THE IRONWORKS

Land At Crabtree Lane

This Design & Access Statement has been prepared by JTP on behalf of Keepmoat Homes, to detail revisions to the Detailed Planning Application for the Land at Crabtree Lane (ref. 142609/F0/2025), which have been made in response to post-submission consultation comments raised by Manchester City Council.

1. Accessible Homes

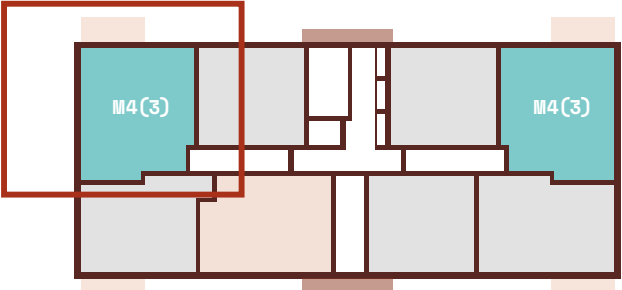
Please can you confirm all accommodation is compliant with M4(2) requirements , and that the units in Block C C-01 and C0-04 and in Block D-10 D-04 would meet M4(3) requirements.

All accommodation is designed to be compliant with M4(2) (please refer to page 77 of the DAS for further details. Apartments C-01, C04, D01 and D-04 are designed as M4(3) compliant.

In Curtilage Parking

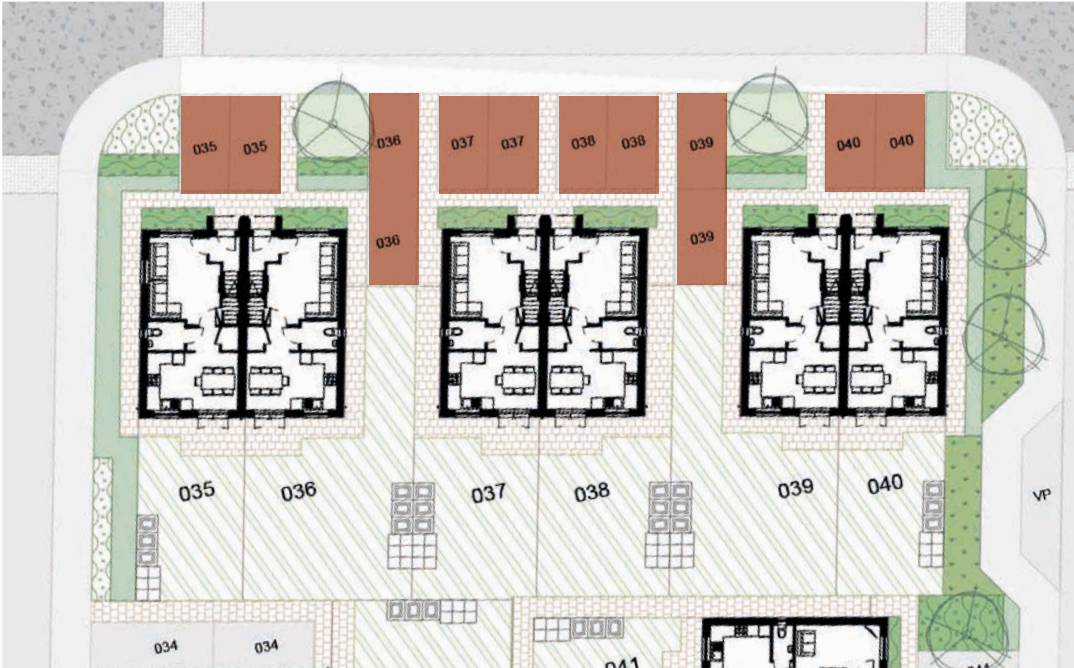
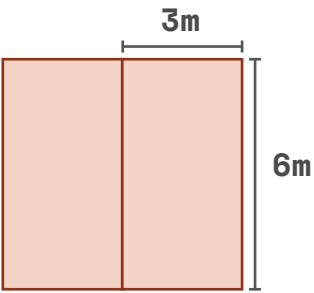
In curtilage parking spaces are noted at 5m x 2.5m. As per pre-application requests driveways should be 6m x 3m.

The layout has been updated accordingly to provide these minimum dimension for driveways serving houses across the site.

Refuse Stores

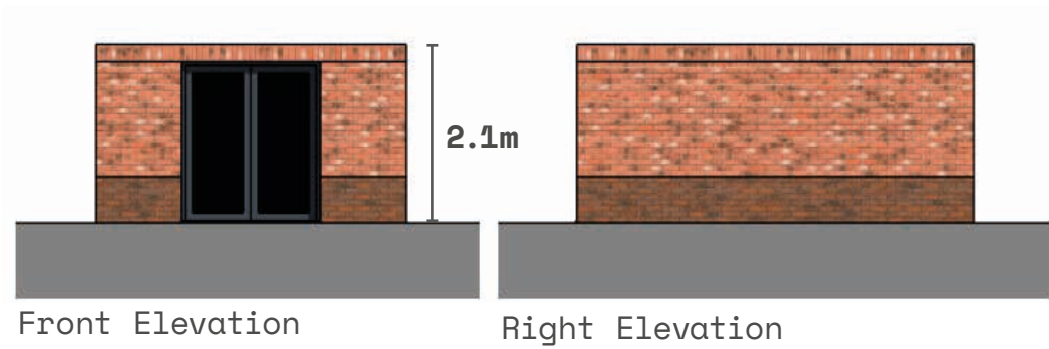
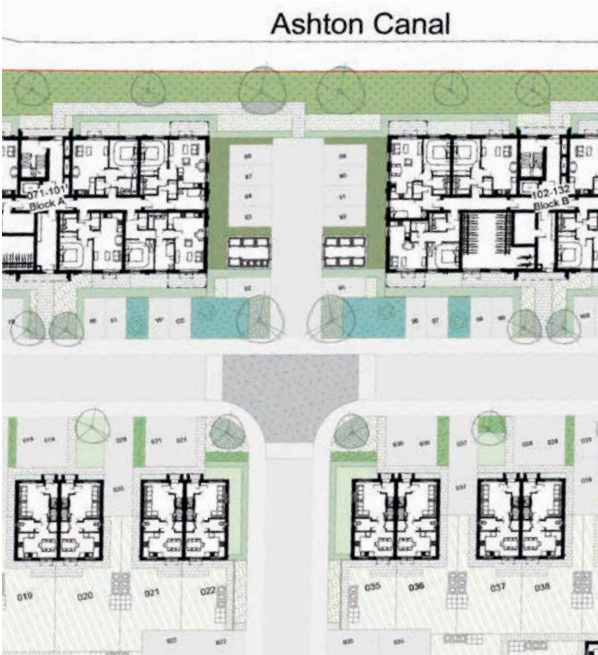
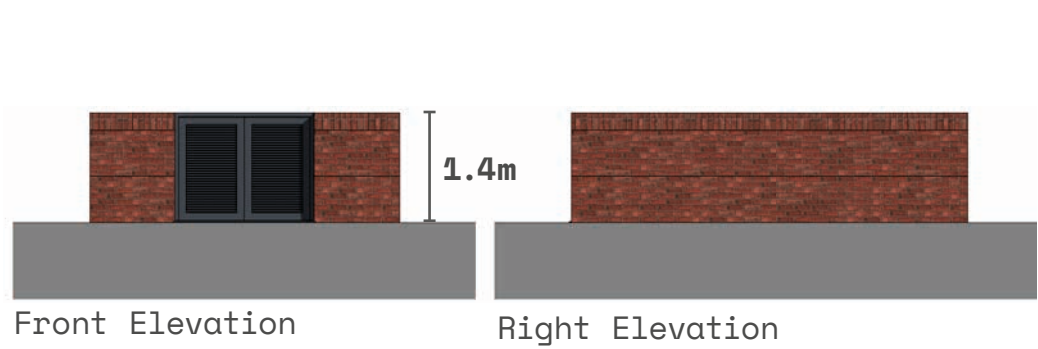
The bin stores serving the apartment blocks would also appear as prominent features in the street scene and dominate the end vistas of the minor roads. The bin enclosures and the carparking should be better screened into the overall layout.

External bin stores to apartments have been reduced in height and push back beyond the building line to reduce their appearance in the street scene. Hedging and tree planting is also incorporated to screen the now lowered structures.

Contrasting Base

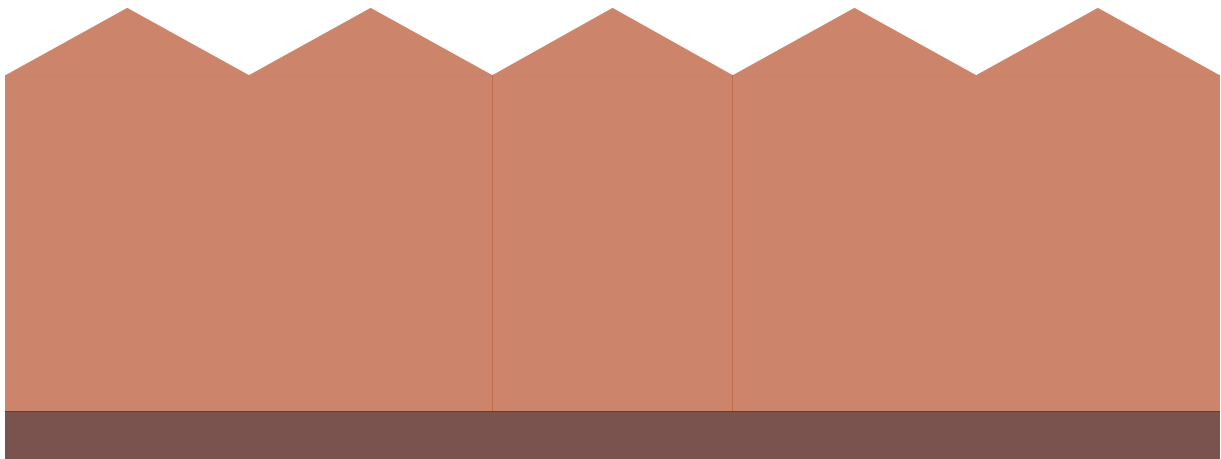
It is noted the aspiration to provide a strong base in a contrasting brick, but should preferably extend the full height of the ground floor.

The design team have tested raising the height of the darker brick base but felt that proportionally this felt out of scale and resulted in a less successful composition.

Window Reveals

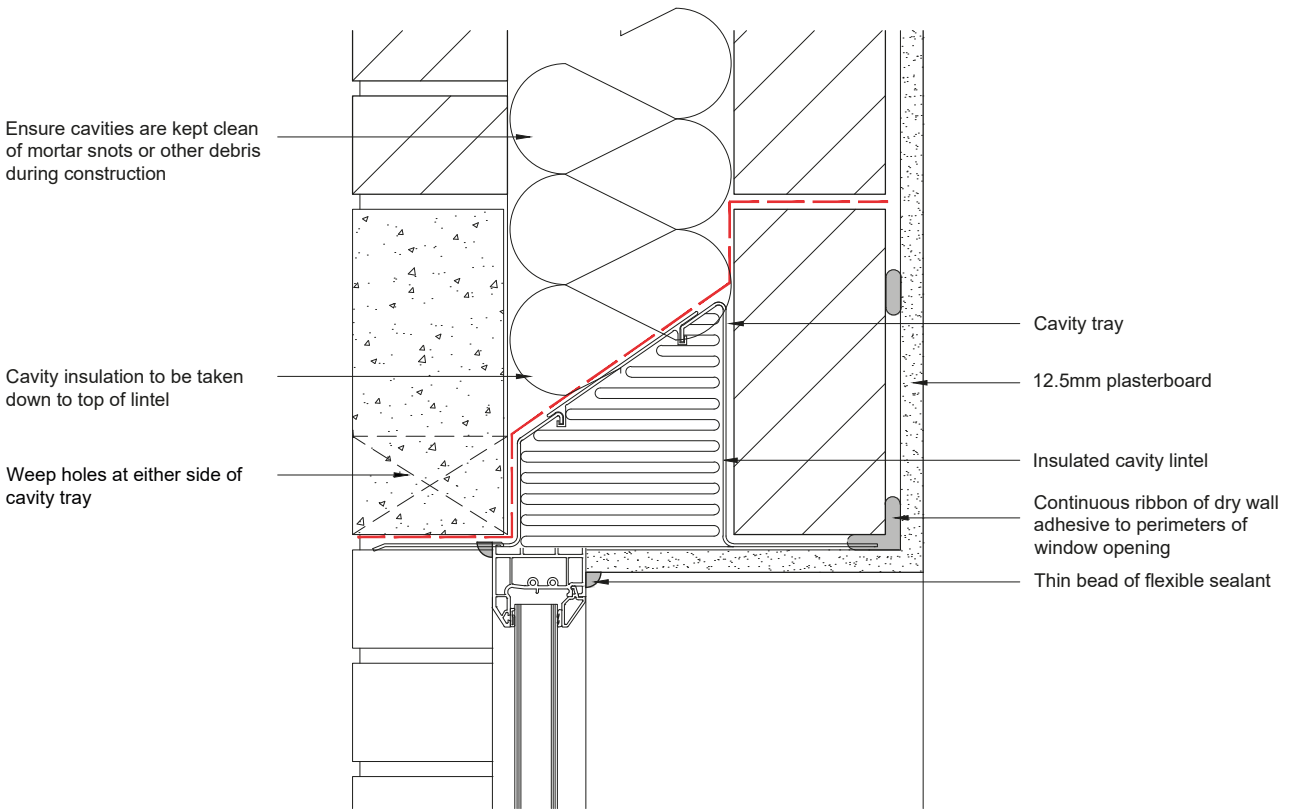
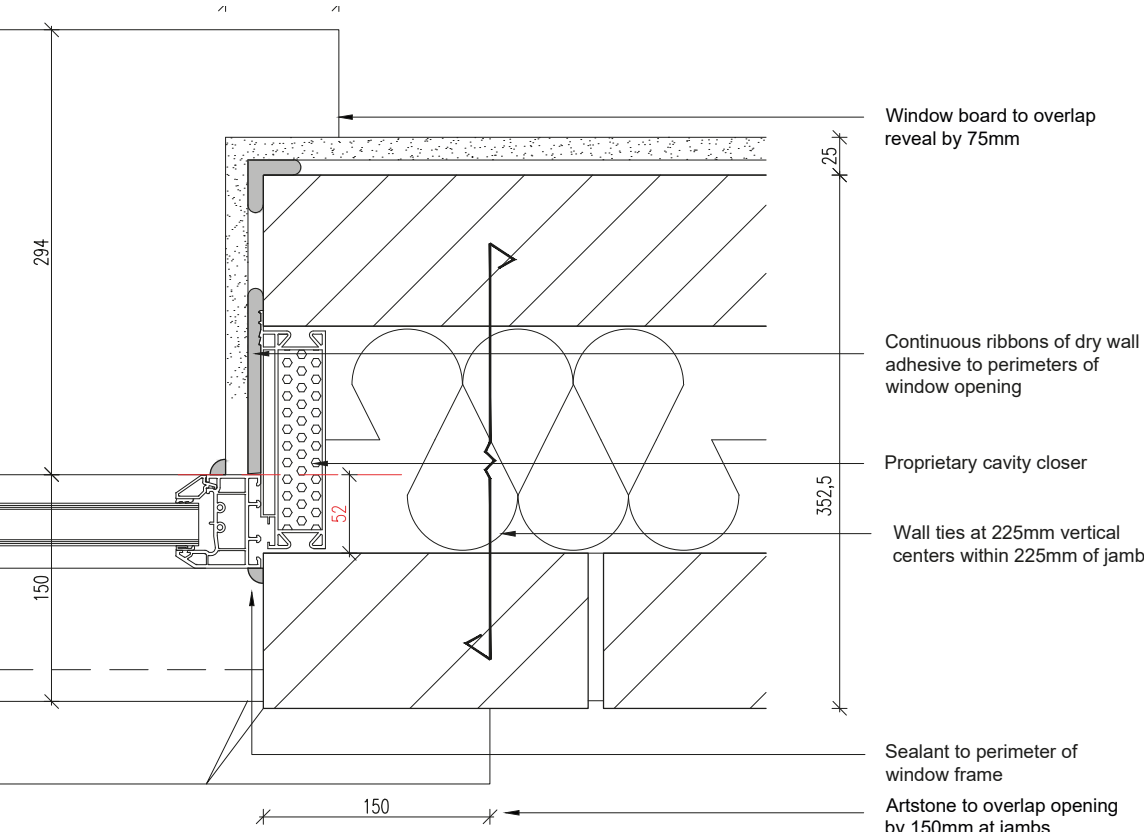
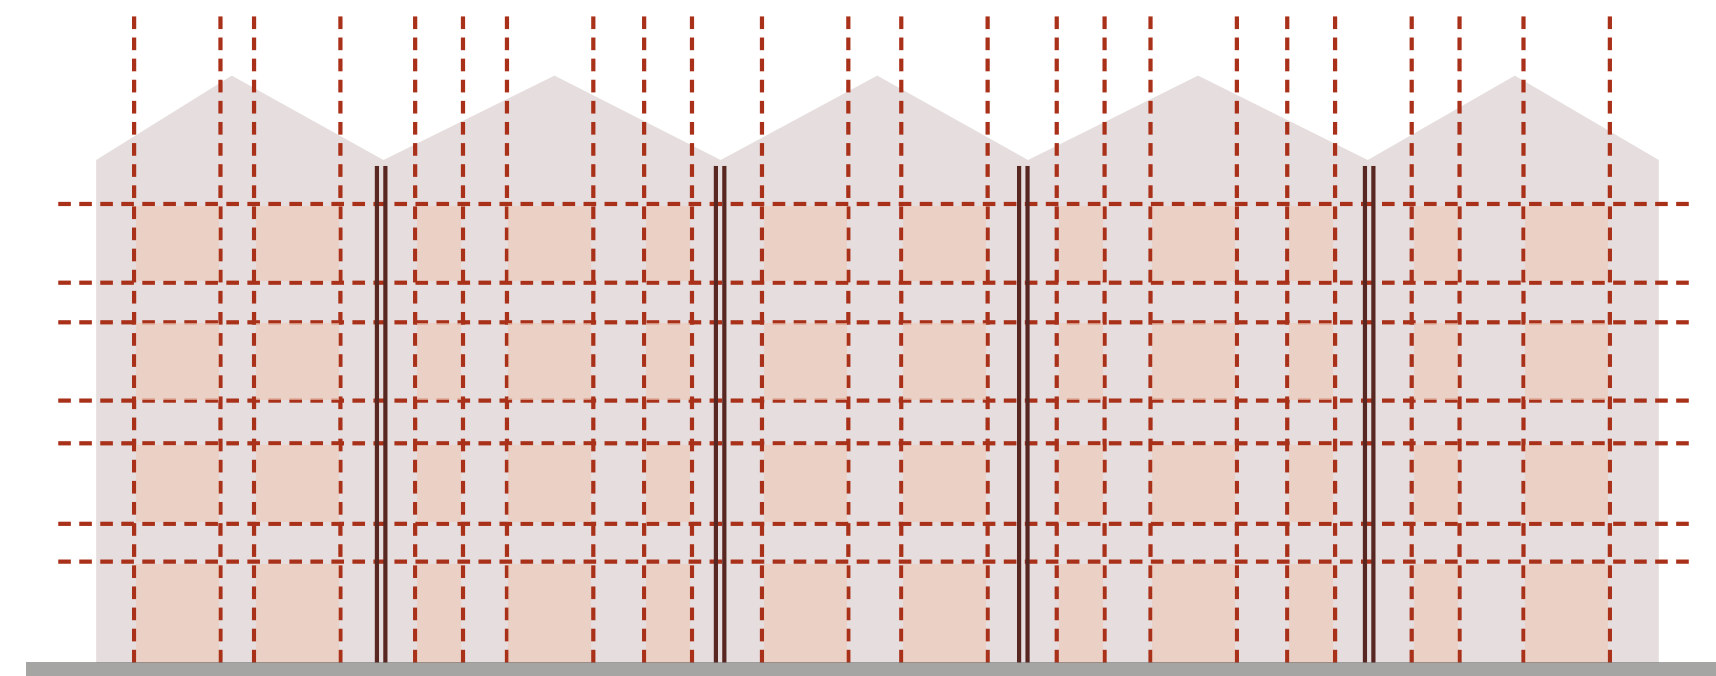
Details with respect to depth of reveals, window and lintel materiality is generally lacking, these are considered important in order to create a high-quality design.

Window reveals have been clarified as circa 90mm to allow panels of brickwork to be inset from the main facade. Typical details are included on this page for information. This reveal depth will be consistent across houses and apartments

The lintel material will be GRC to provide a high-quality finish.

Materiality

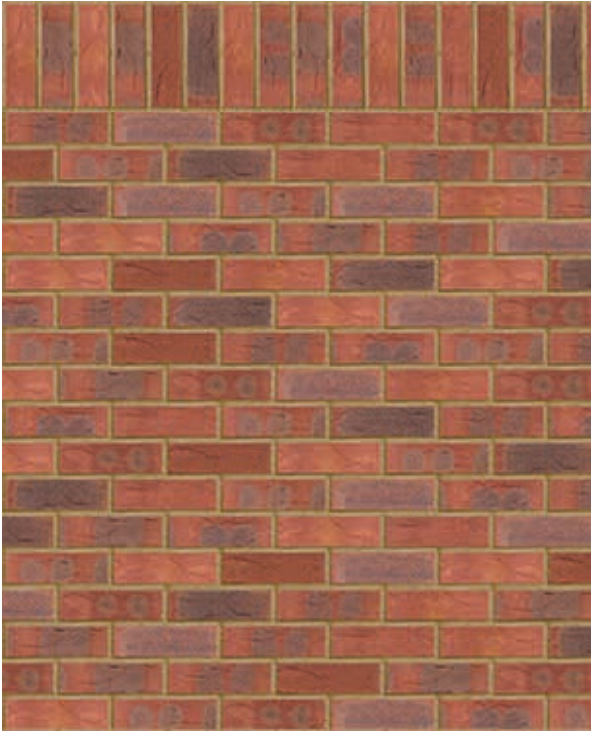
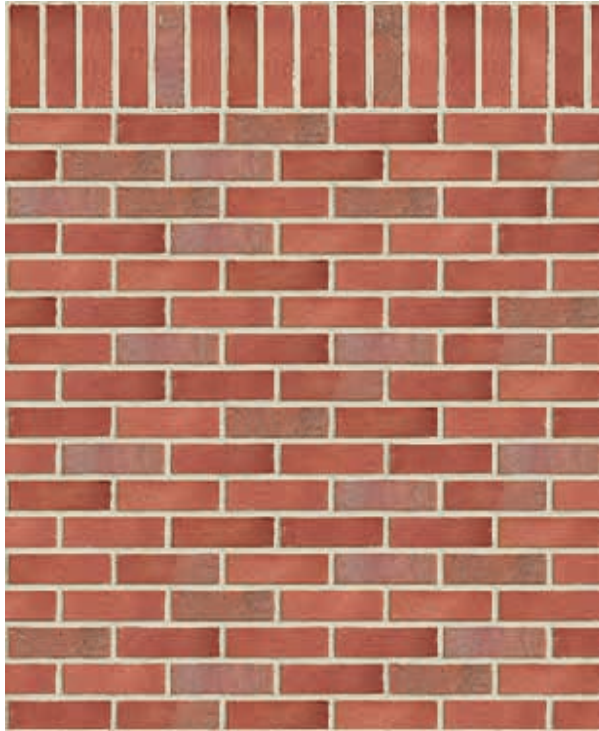
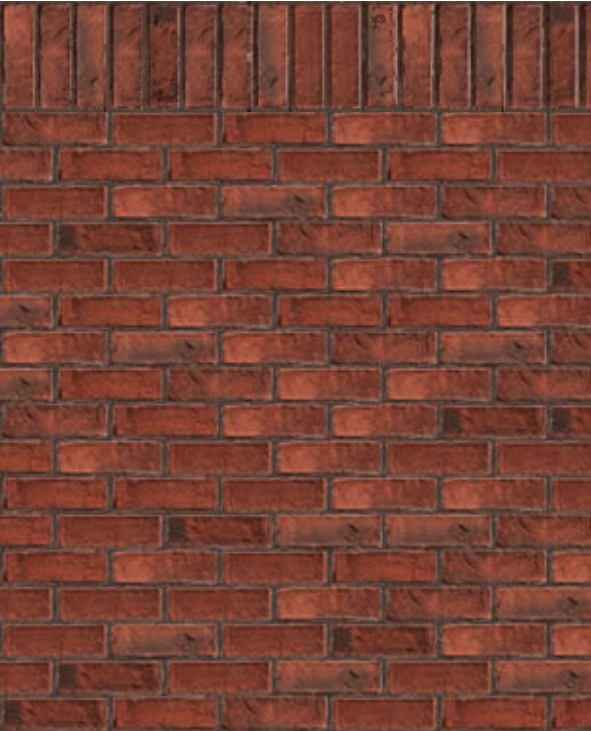
The use of brick is supported, but there are reservations as to the use of brown brick and a brick sample would be required for consideration.

Brown bricks have been removed from the material palette in favour of a darker red which will suitably contrast with the primary red bricks.
